Site Accessibility Evaluation

Americans with Disabilities Act Title II (Public Services: State and Local Government)

Fair and Events Complex

**366 10th St
Calhan, CO 80808**

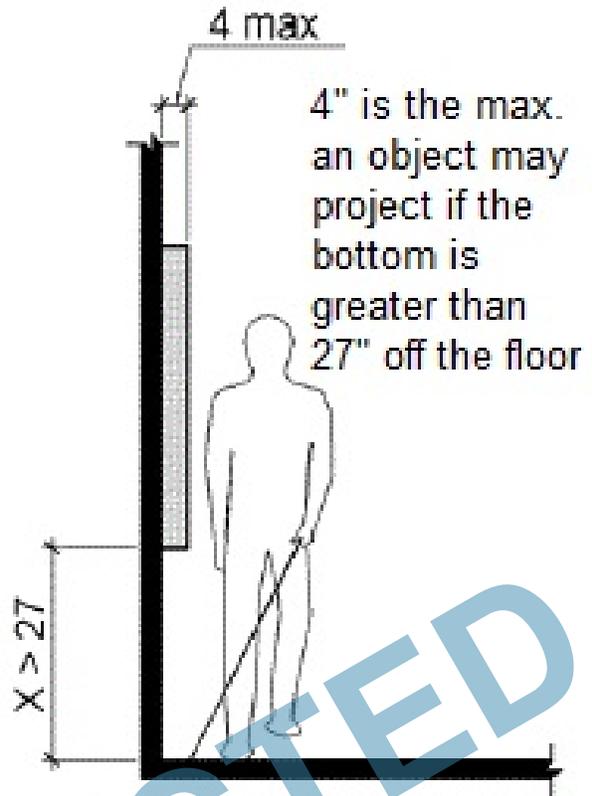
If possible, replace AED housing with low profile housing or recess housing into wall to meet the 4 inch maximum protrusion or place AED away from circulation path.

Finding 297886 Main Photo

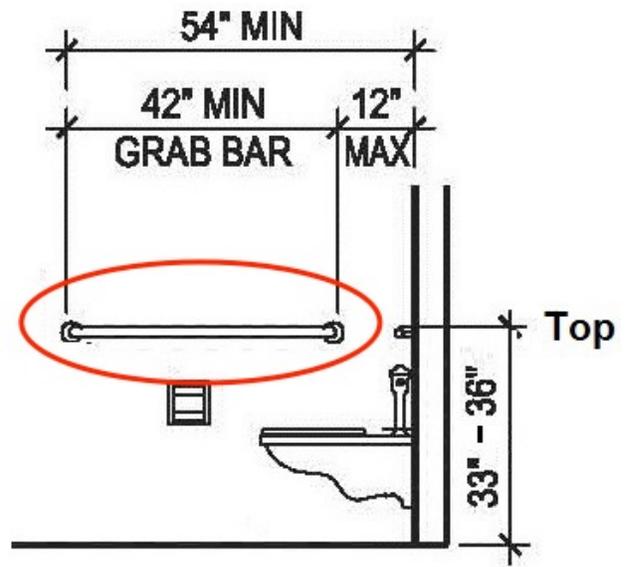
Finding #30 Continued

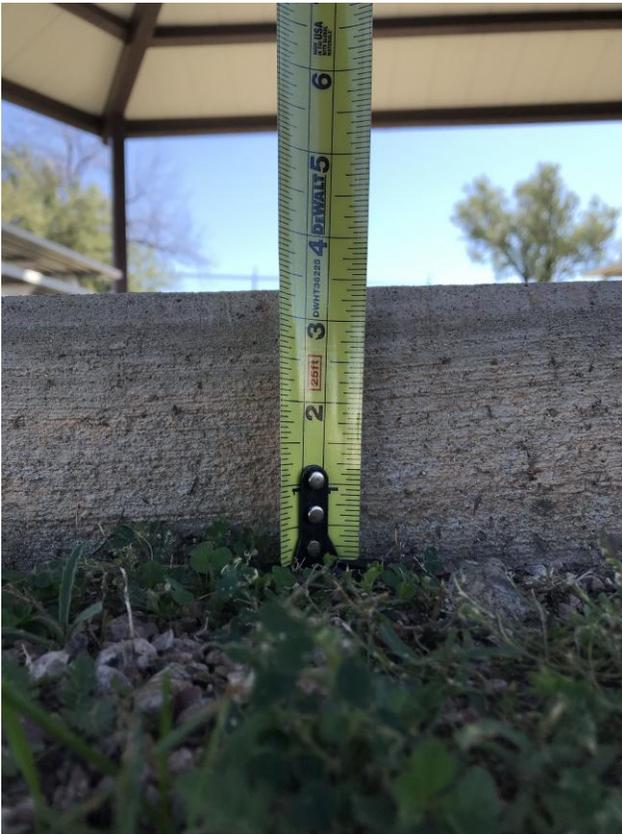
3.5 inches vertical change

Entrance not accessible to mobility devices due to the obstruction at the entrance. Recommend backfilling dirt/gravel to ensure a change in level no more than 1/4 of an inch or install an ADA ramp as used in school playgrounds or construct concrete ramp.

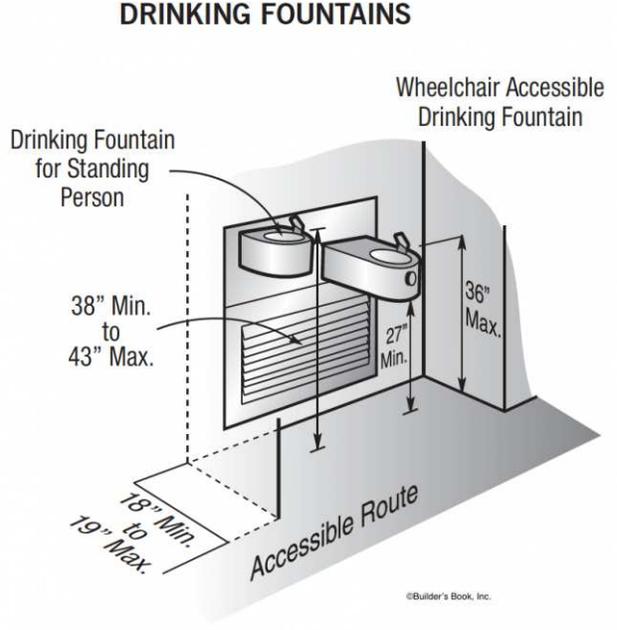
Replace existing drinking fountain with a HiLo drinking to meet ADA compliance. Ensure knee compliance is met and set at 27 inches exactly from bottom edge of drinking fountain to finished floor.

Finding 297952 Main Photo

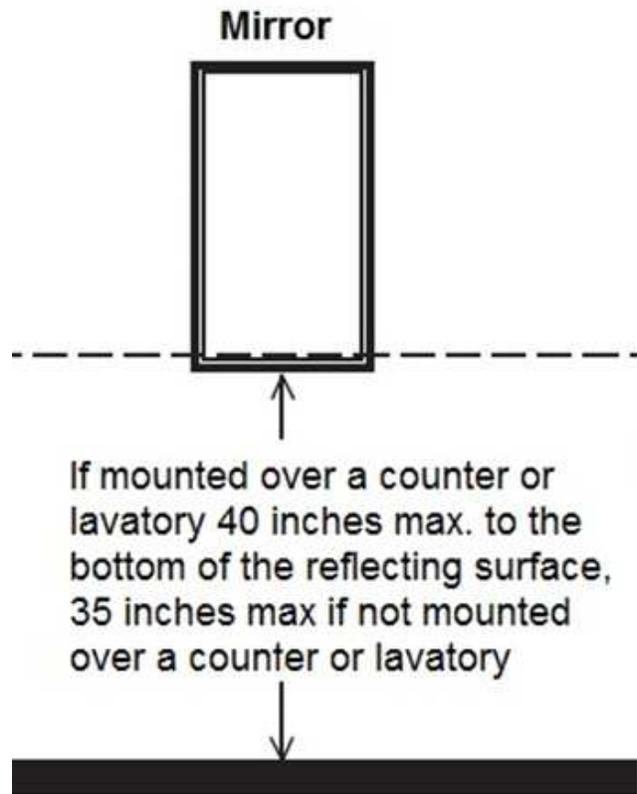
Finding #75 Continued

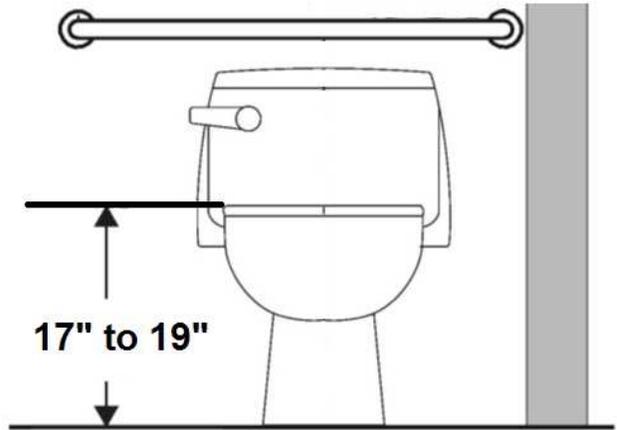
Adjust toilet height, replace toilet or replace toilet seat with one that will meet the minimum height requirement of 17 inches.

Finding 298271 Main Photo

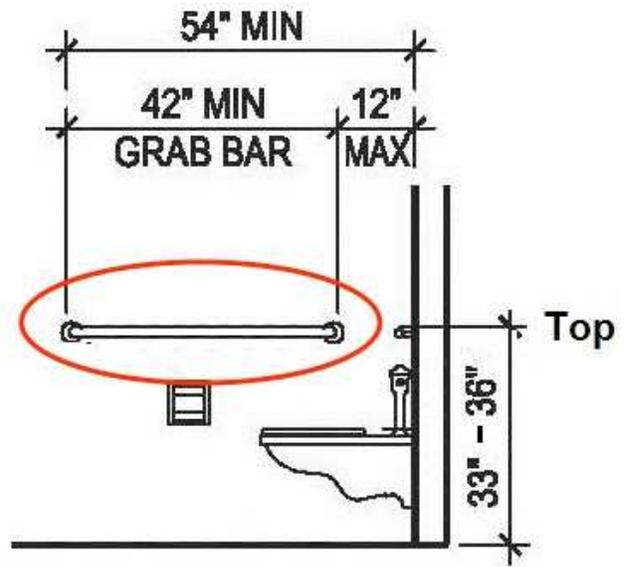
Finding #141 Continued
